Amendments to the Drawings:

Remarks

Drawing Objections

Figure 1.

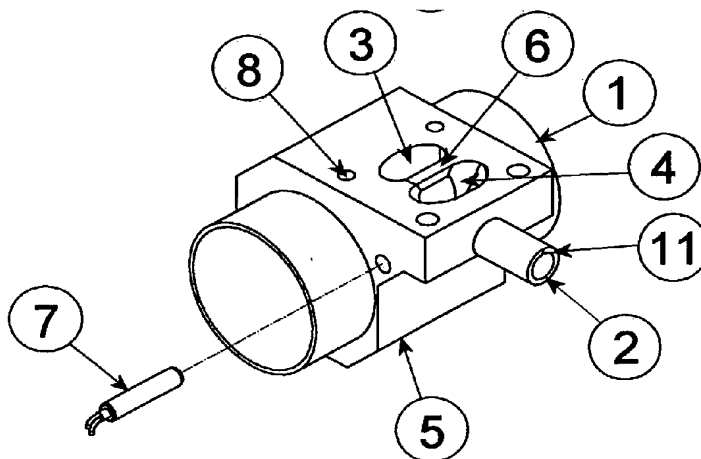
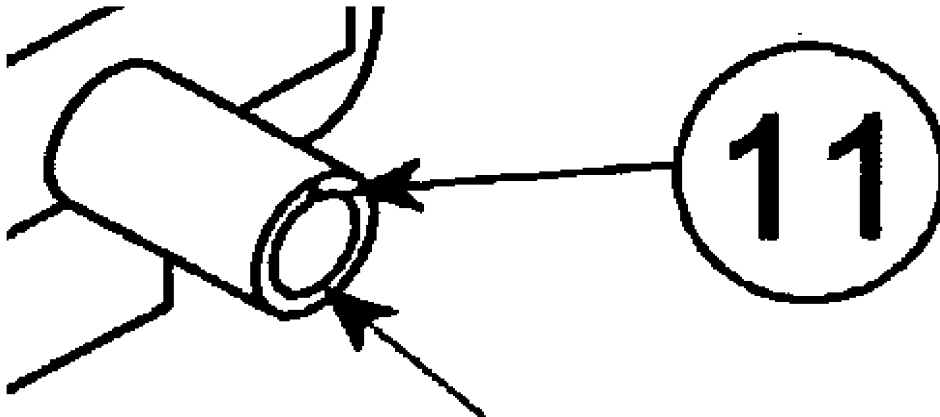
The Examiner has objected to the drawings, stating that "there is no adequate support for such a notch or for an axially extending discontinuity in the original application." (Page 2 of the Office Action of October 14, 2009). And "Figure 1 uses the label 11 and does not show a notch or an axially extending discontinuity." *Id.* Applicant respectfully disagrees. The notch/discontinuity 11 is present in Figure 1. Below is a portion of Figure 1 as originally filed.

A closer examination of Figure 1 illustrates the notch/discontinuity 11 formed on an upper portion of the downstream connector 2, as shown below.

Figure 2.

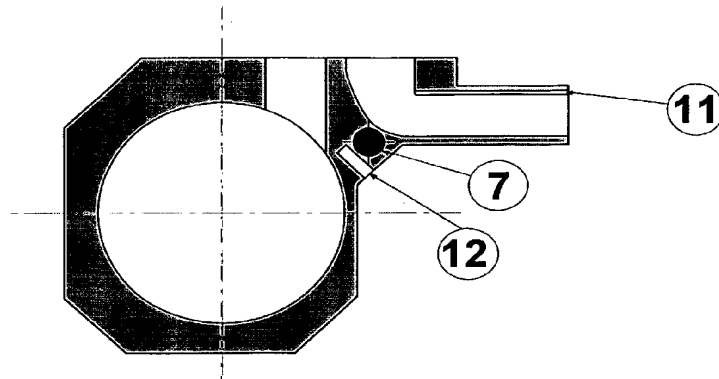
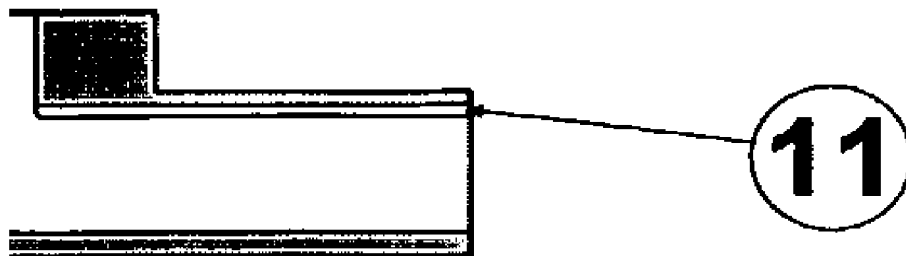
Applicant discloses "[w]ith reference to Figure 2, . . . the down stream connector plain outlet type nozzle (2) can be optionally contoured on the upper portion of said nozzle, as shown (11) to help assist in unlocking any held-up medium in the nozzle when the valve is closed in order to promote rapid free draining of the nozzle." (Specification at page 6, starting at line 5, as amended by this paper). The Examiner states "[i]n particular, Figure 2 is ambiguous since the upper part of nozzle 2 is shown as being the same as the lower part, which does not have a notch". (Page 2 of the Office Action of October 14, 2009). Applicant respectfully disagrees. The upper and lower portions of the downstream connector are not shown as being the same in Figure 2. Figure 2 as filed is illustrated below.

A closer examination of Figure 2, illustrates the notch/discontinuity 11 axially extending along the length of the downstream connector.

FIG. 2

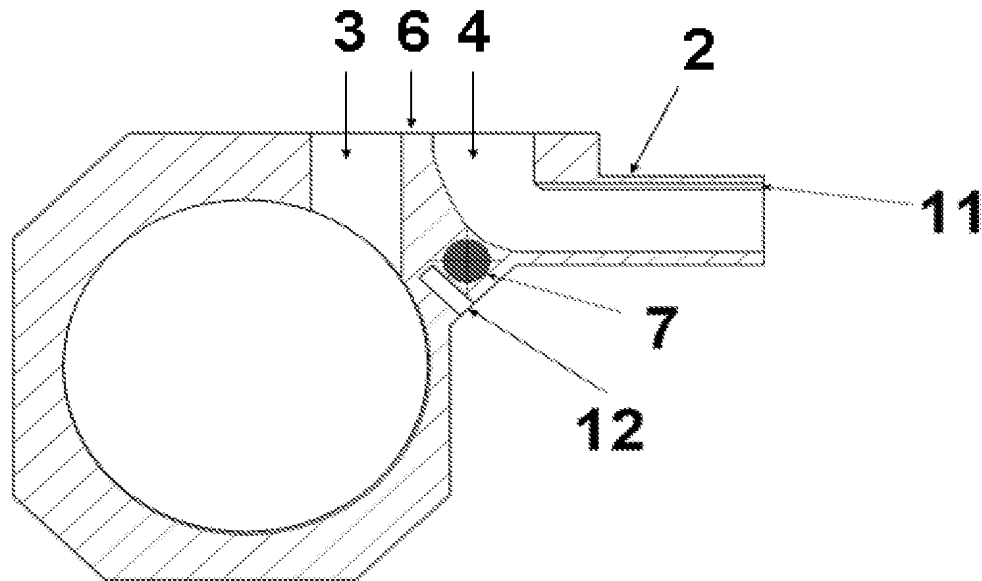
By this paper applicant withdraws Figures 1A, 1B and 2A which were added in the amendment filed on January 16, 2009, to further prosecution. The remaining Figures 1 and 2, previously presented in the amendment of January 16, 2009 are clearer reproductions of Figures 1 and 2 as originally filed and do not present new matter. Replacement Figure 2 is shown below and illustrates the notch/discontinuity formed on the upper portion of the downstream connector 2.
